**1.0 APPLICATION DETAILS**

Ref: 21/01298/FUL  
 Location: 62 The Ridge Way, South Croydon, CR2 0LF  
 Ward: Sanderstead  
 Description: Demolition of the existing dwelling and creation of 9 new family-sized dwellings, 5no. houses and 4no.maisonettes with associated parking, landscaping and children's play area.

*Figure 5: Proposed Streetscene Elevations*

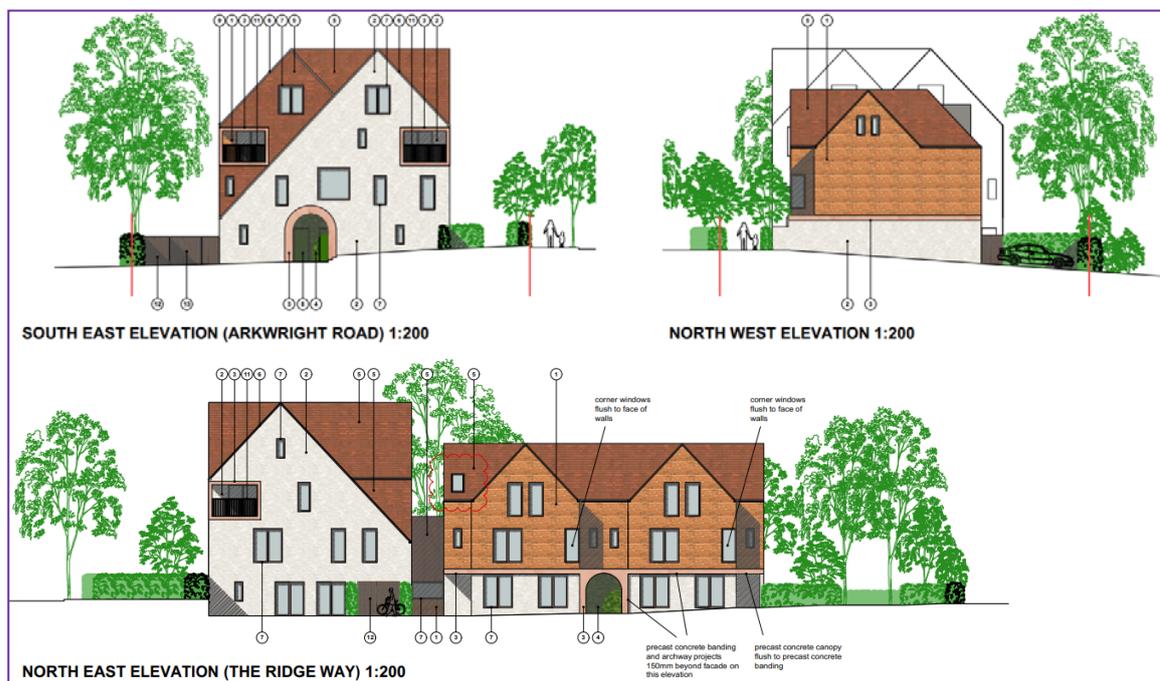
- 7.14 CLP policy DM10.1 states that new development should seek to achieve a minimum height of 3 storeys. The proposed development is three storey plus accommodation in the roof space facing Arkwright Road, as it decreases with the gradient, and three storeys on The Ridge Way. The front and side elevations have a cat slide roof which allows a gentle and appropriate transition in scale to the neighbouring building on Arkwright Road. The maximum height is achieved in a sensitive and architecturally coordinated responsive manner as the elevations echo the gables, eaves and cat slide roof forms of properties found in the area. The appropriate scaling of the development, in co-ordination with its design, successfully allows it to form a building of an acceptable scale, whilst also being responsive to neighbouring properties, as such meets the objectives of the Suburban Design Guide SPD (SDG).

Figure 7: Proposed Block Plan

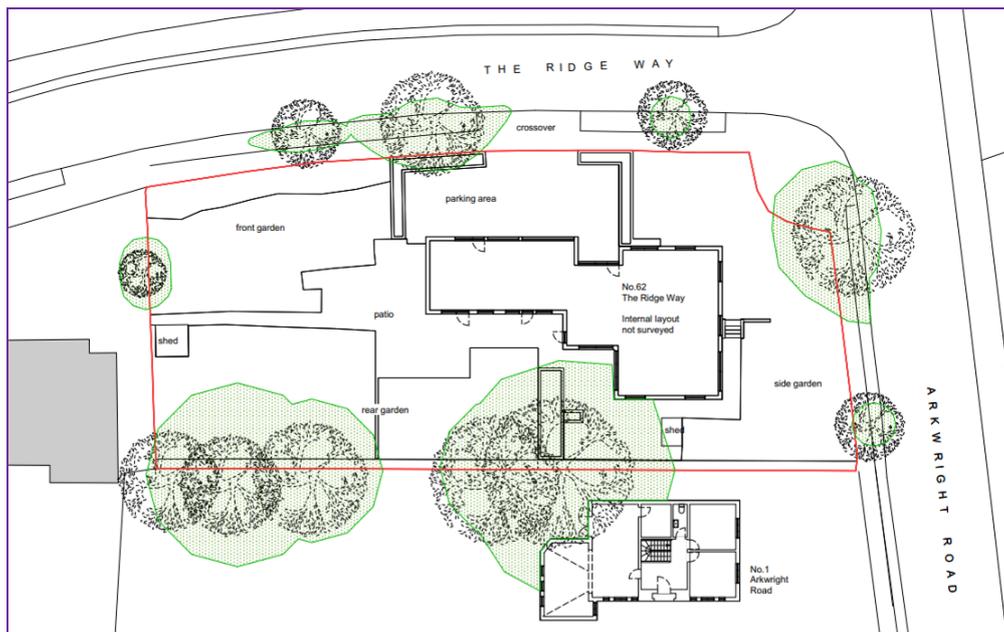
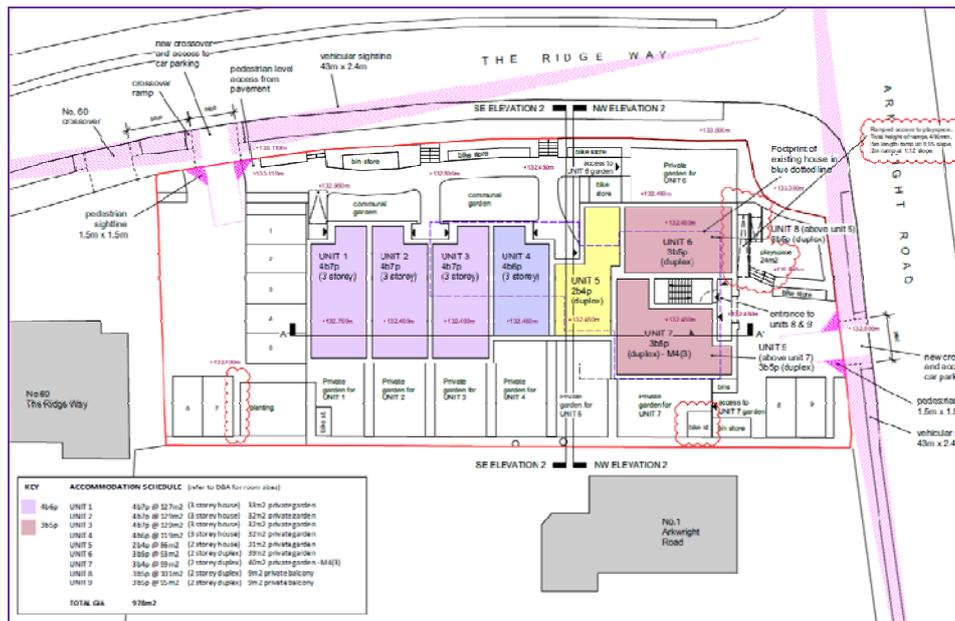
- 7.17 Car parking would be primarily located to the north/north-west of the site from The Ridge Way, with 2no. spaces in the south/south-eastern side of the site, facing onto Arkwright Road. The existing site has a large side garden, which gives visual separation between the existing dwellinghouse and the neighbouring property at No. 60 The Ridge Way; the proposal scheme would have car parking situated in the area beside No. 60, therefore, this retains the visual separation of the buildings. This is demonstrated in the plans below, which show a comparison of the existing and proposed block plan.

Figure 9: Diagram of 10m perpendicular outline

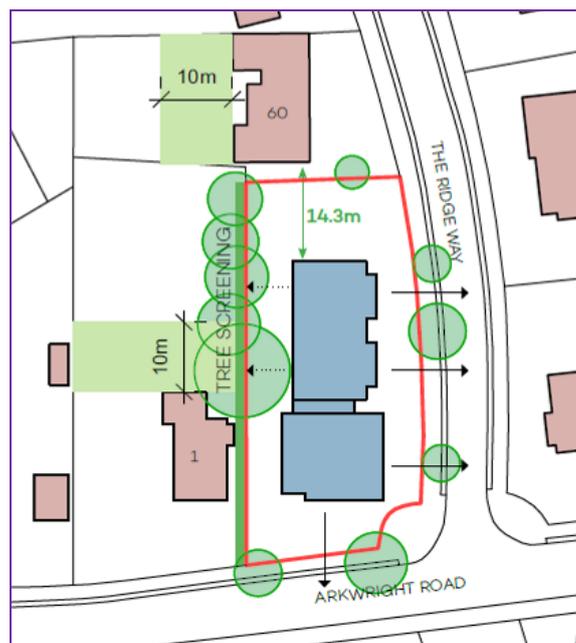
- 7.46 CLP policy DM10.6(c) outlines that proposals for development should not result in direct overlooking of private outdoor space (with the exception of communal open space) within 10m perpendicular to the rear elevation of a dwelling.

- 7.47 While the boundary treatment cannot be relied upon solely, given that the first floor and dormer windows would have opaque glazing up to 1.7m from internal floor level, this would ensure the privacy of the neighbouring property is protected.
